## Zoning Board of Appeals Application

1. ADDRESS OF THE SUBJECT PROPERTY: 3991 Crooks Road and adjacent parcels on the southwest corner making up the proposed project Pinnacle of Troy
2. PROPERTY TAX IDENTIFICATION NUMBER(S): 20-20-226-015, -016, -017, -106
3. ZONING ORDINANCE SECTIONS RELATED TO THE REQUEST: 5.06.E.3.c.i Height Limit
4. HAVE THERE BEEN ANY PREVIOUS APPEALS INVOLVING THIS PROPERTY? If yes, provide date(s) and particulars: None
5. APPLICANT:  
NAME David Donnellon  
COMPANY J & A Architectural Engineers  
ADDRESS 6001 N, Adams Rd,  
CITY Bloomfield Hills STATE MI ZIP 48304  
PHONE 248,225,1436  
E-MAIL donnellon.architect@gmail.com  
AFFILIATION TO THE PROPERTY OWNER: Owner's Architecture and Planning Consultant

SUBJECT: PRELIMINARY SITE PLAN REVIEW (SP JPLN2024-0014) – Proposed Pinnacle of Troy, Troy, Southwest corner of Crooks and Wattles (3991 Crooks; PIN 88-20-20-226-015, -016, -017, & -106), Section 20, Currently Zoned NN (Neighborhood Node “I”) District.

## **Consideration of a Preliminary Site Plan For City of Troy, Michigan**

DRAWING TITLE  
**PRELIMINARY SITE PLAN**

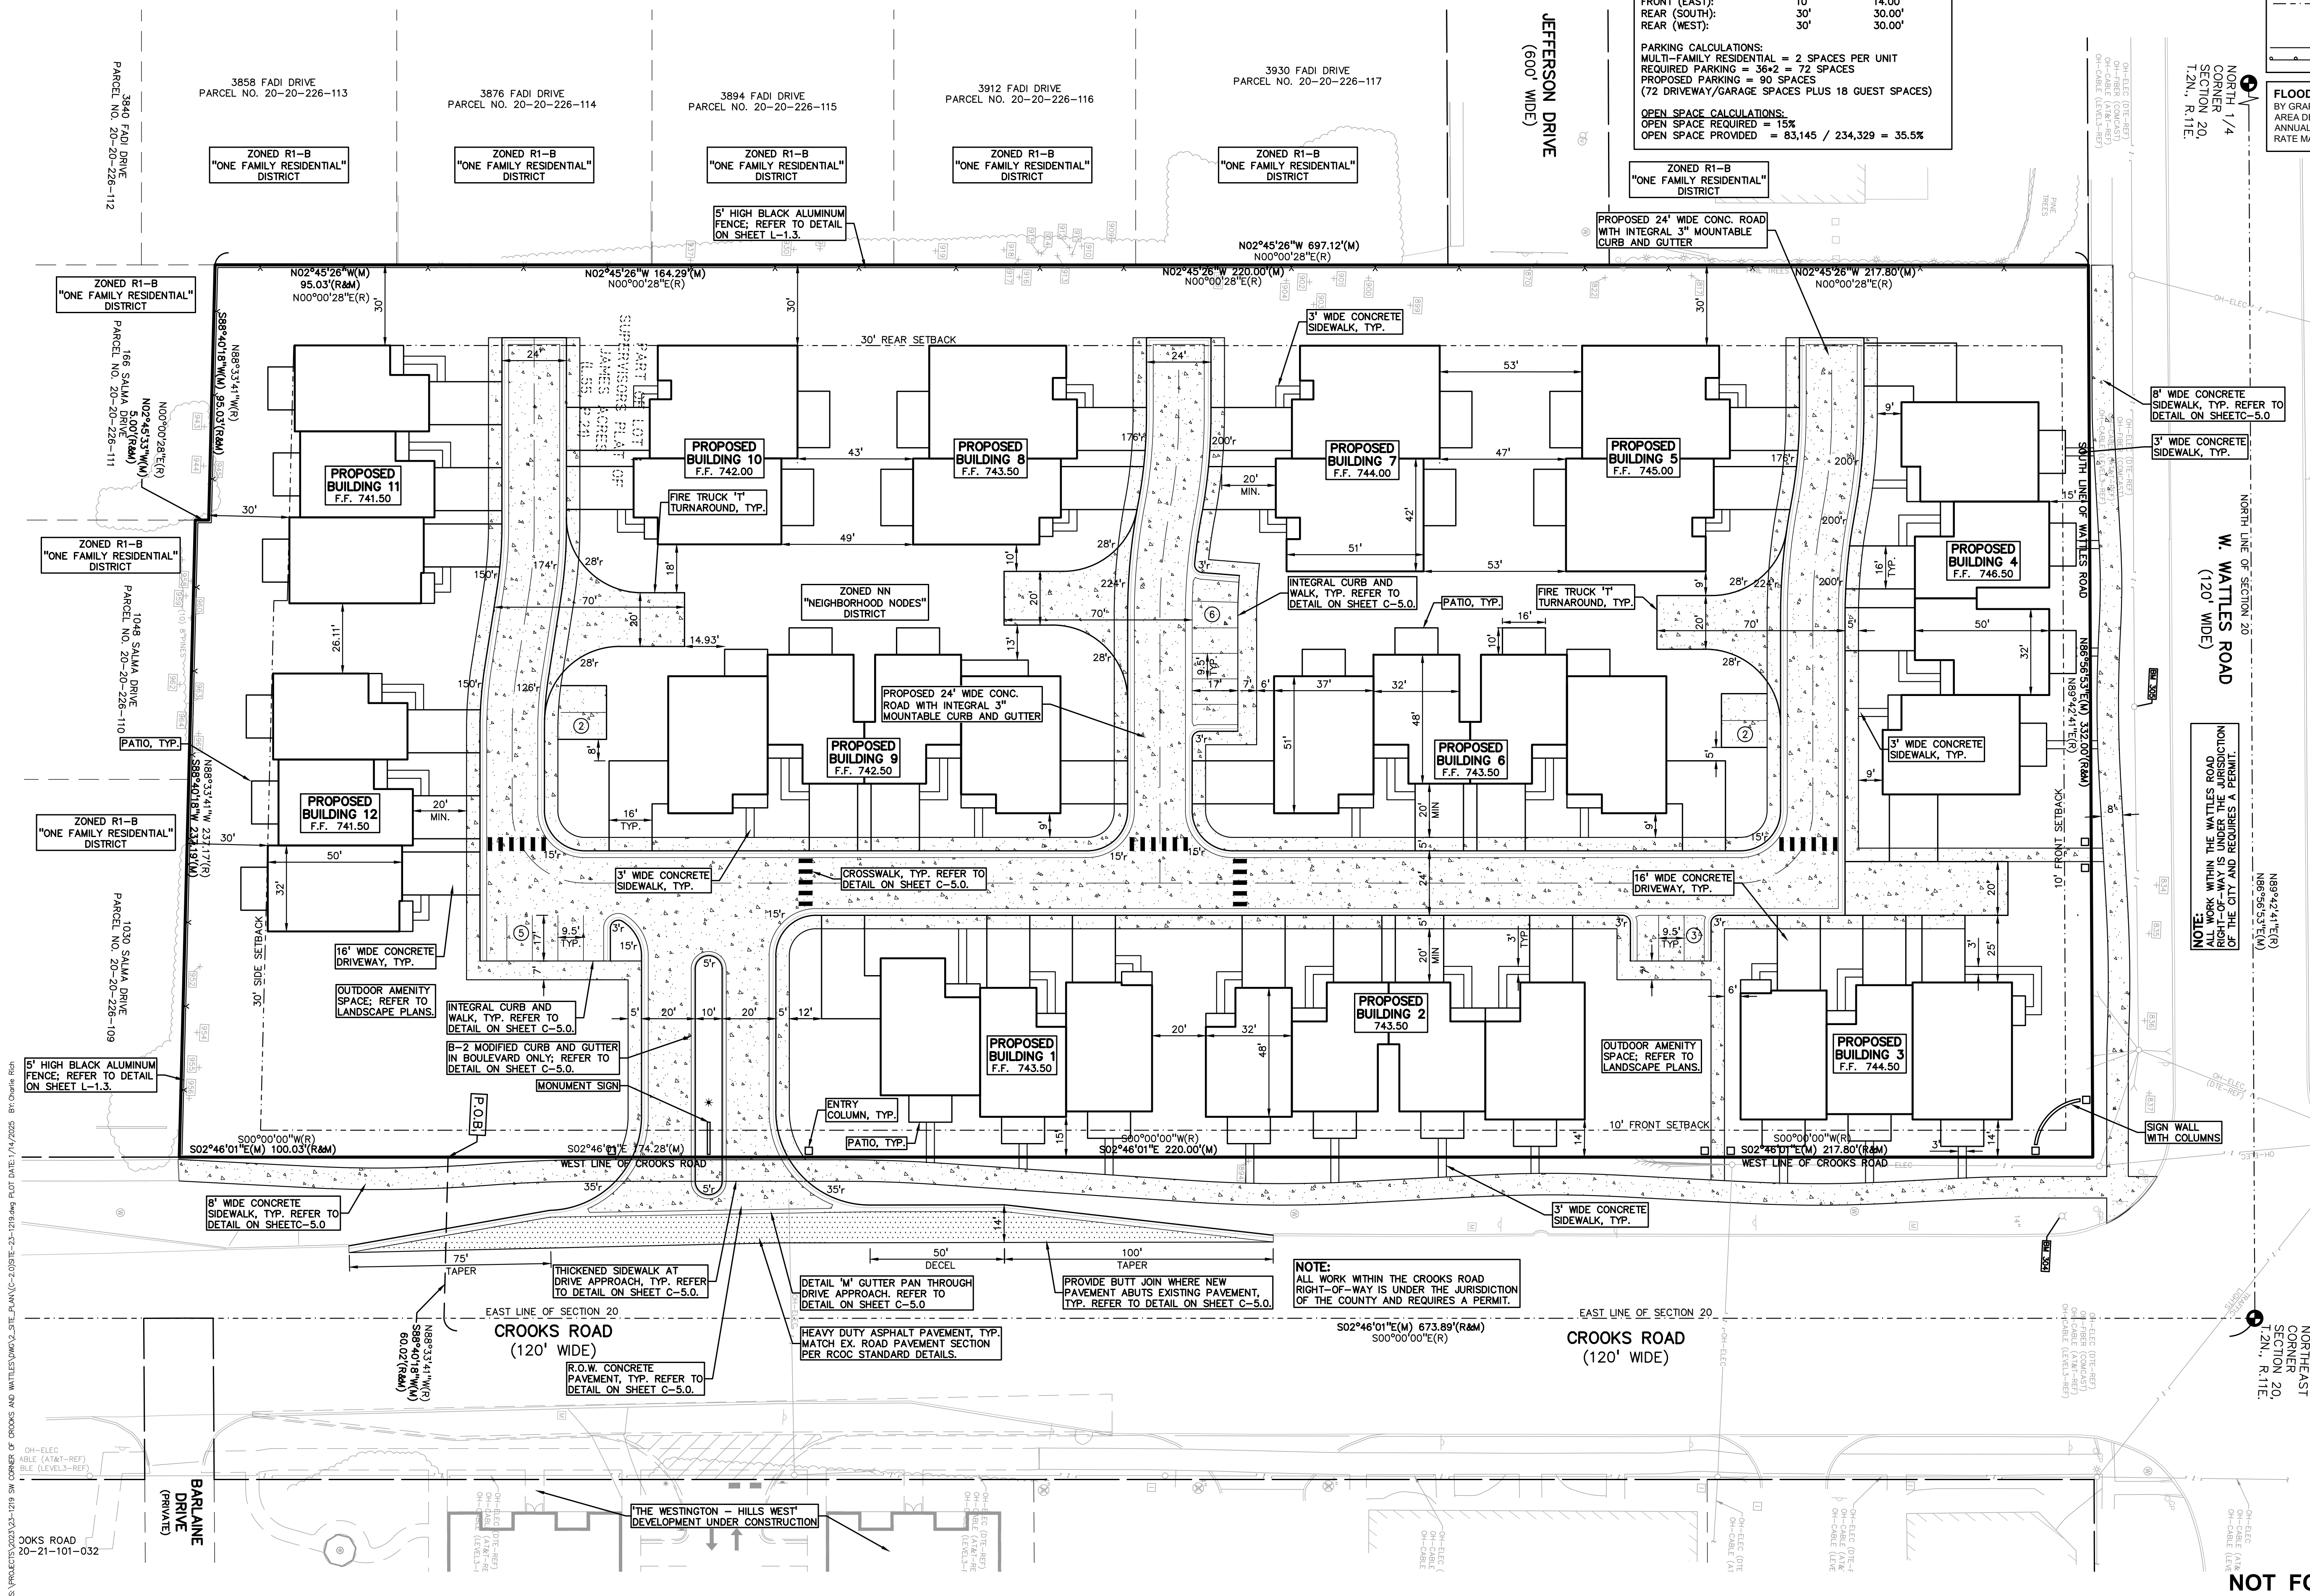
Required	Provided	Compliance
Front (Wattles)	10-foot build-to line	15 feet	Needs relief from Planning Commission. See Discussion Below
Front (Crooks)	10-foot build-to line	14 feet	Needs relief from Planning Commission. See Discussion Below
Side (West)	N/A, building may be placed up to property line	30 feet	Complies
Rear (South)	30 feet minimum	30 feet	Complies

**Items to be Addressed:** 1). Planning Commission consideration of increased front setbacks; and 2). Planning Commission shall review the site plan, but shall not grant preliminary site plan approval until a variance decision is reached by the ZBA.

DRIVING TITLE:  
**FLOOR PLANS**  
SCALE: 1/8" = 1'-0"  
BLDG'S. 2 & 4

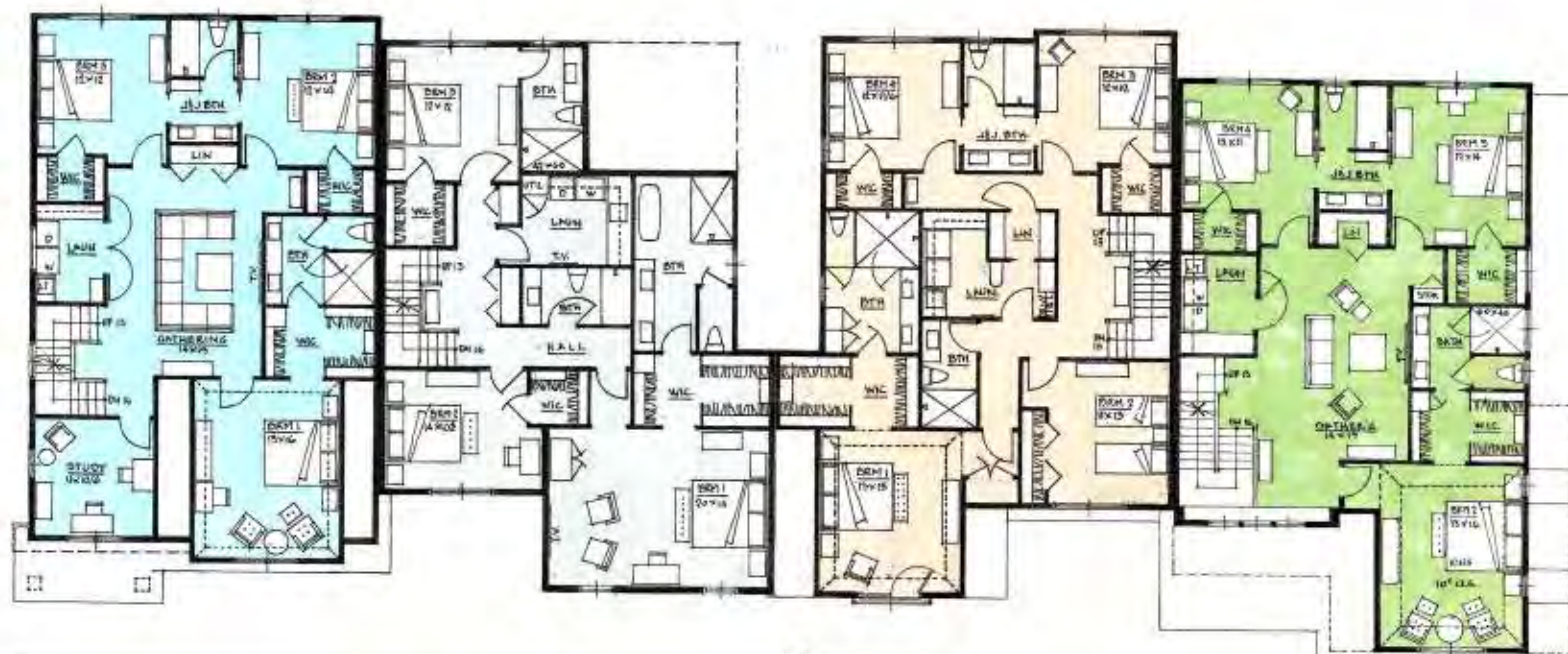
The applicant proposes a total of thirty-six (36) units, split between twelve (12) buildings. Four (4) different floor plans are provided on Sheet A-2 and each unit will match one of these floor plans. Each unit is 2.5 stories. Technically, each unit has a basement, two (2) full stories, and a half-story “loft area” at the top.

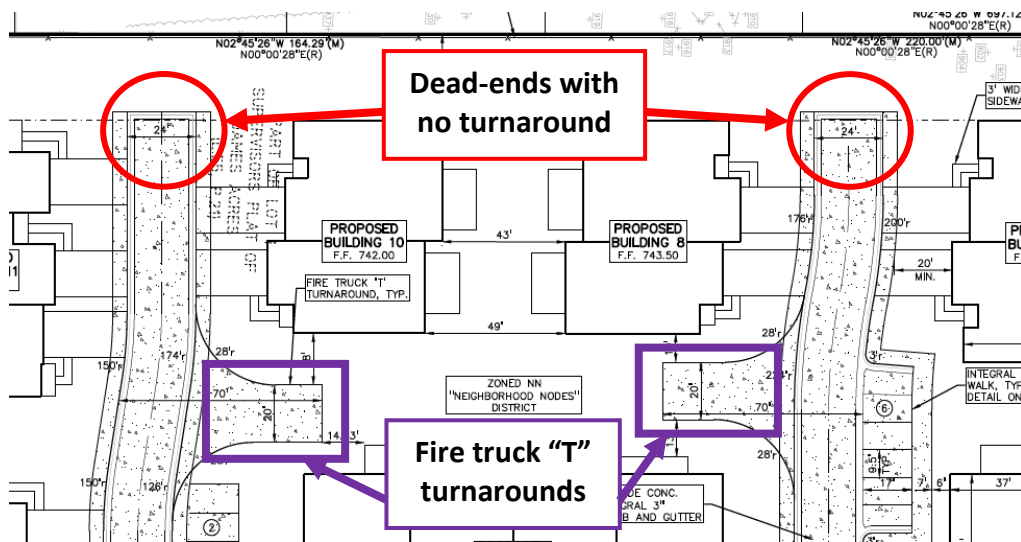
The amount of parking proposed by the applicant exceeds the required number by more than 20%. We recognize that excessive parking reduces aesthetic standards and contributes to high and unnecessary rates of stormwater runoff. For these reasons, the City requires applicants to receive approval when exceeding parking requirements by more than 20%.

In a previous review, we informed the applicant that parking would need to be reduced or documented evidence justifying the parking need would be required to receive approval from the Planning Commission. Since then, five (5) spaces have been removed from the site plan; however, parking still exceeds 20%, and no evidence-based justification has been provided. It appears that the applicant intends to discuss this with the Planning Commission without documented evidence.

**Items to be Addressed:** Reduce parking or provide documented evidence justifying the need for excess parking.
